UNITED STATES PATENT AND TRADEMARK OFFICE

APPLICATION NO.	FILING DATE	FIRST NAMED INVENTOR	ATTORNEY DOCKET NO.	CONFIRMATION NO.
10/073,826	02/11/2002	Robert J. Medoff	U 013871-4	5504

Office Action Summary	Application No. 10/073,826	Applicant(s) MEDOFF, ROBERT J.	
	Examiner Eduardo C. Robert	Art Unit 3732

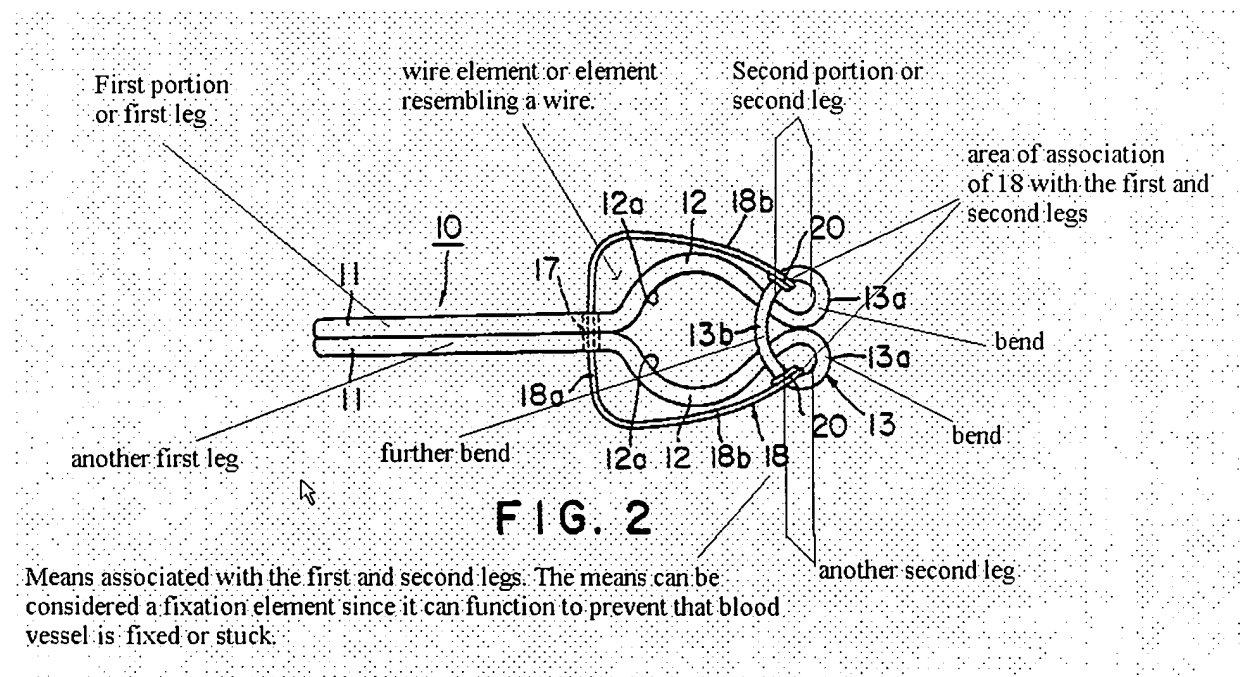
Claims 1, 37-39, 42, 48, 50, and 56 are rejected under 35 U.S.C. 102(b) as being anticipated by Segawa et al. (U.S. Patent No. 5,312,426).

Segawa et al. disclose an apparatus comprising a first portion or first leg, a second portion or second leg integrally formed with the first portion or leg by a bend, and a means 18 associated with the second leg (see Figure 2 below). It noted that the means 18 can be considered as a fixation element since it can function to prevent that a blood vessel is fixed or stuck.

The apparatus can be considered a wire element since it resembles a wire that has been twisted. Actually, as shown above, the wire element has two first portions or legs and two second portions or legs, each being joined by respective bends and the two second portions or legs are connected together by a further bend which lies in a plane with the second legs. The first and second legs have different cross-sectional areas and diameters (see Figure 3). The second legs are spaced from one another (see Figure 2 above). The first legs extend beyond the second legs (see Figure 2 above). With regard to the functional language recited in the claims, e.g. "adapted to ...", etc., it is noted that the manner in which a device is intended to be employed does not differentiate the claimed apparatus from prior art apparatus satisfying the claimed structural limitations. Ex parte Masham, 2 USPQ2d 1647 (1987). Furthermore, it has been held that the recitation that an element is "adapted to" perform a function is not a positive limitation but only requires the ability to so perform. It does not constitute a limitation in any patentable sense. In re Hutchison, 69 USPQ 138. In the instant case the apparatus of Segawa et al. has the ability to perform the function recited in the claims if one so desire.

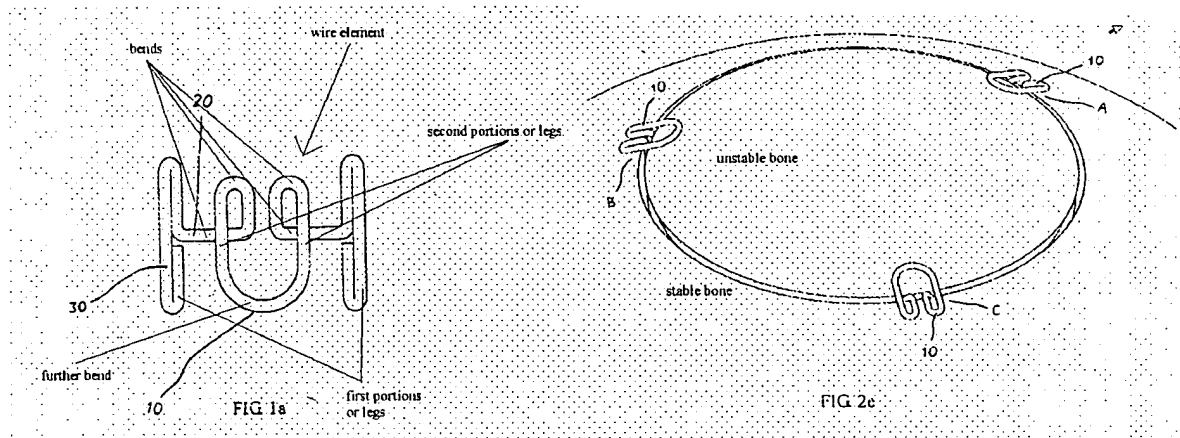
Claims 1, 37-39, 40, 42, and 48 are rejected under 35 U.S.C. 103(a) as being unpatentable over Lee (U.S. Patent No. 6,554,835) in view of Medoff (U.S. Patent No. 5,709,682).

Lee discloses an apparatus comprising a wire element or element resembling a wire, the element includes first portions or legs, second portions or legs, bends connecting the first portions with the second portions, and a further bend connecting the second portions or legs (see Figure 1a below). The apparatus is used to attached an unstable bone to stable bone (see Figure 2e below). The first and second portions of the apparatus of Lee have the ability to perform the function recited in the claims if one so desire.

Lee discloses the claimed invention except for the apparatus having a washer and bone screw. Medoff discloses an apparatus having first portions or legs and second portions or legs, and a washer, e.g. 96, engageable with the second portion legs and a bone screw, e.g. 94. The washer and bone screw secured the apparatus to a stable bone. It would have been obvious to one skill in the art at the time the invention was made to construct the apparatus of Lee including a washer and bone screw in view of Medoff, in order to secure more the apparatus to a stable bone, thus insuring that the unstable bone portion does not move.
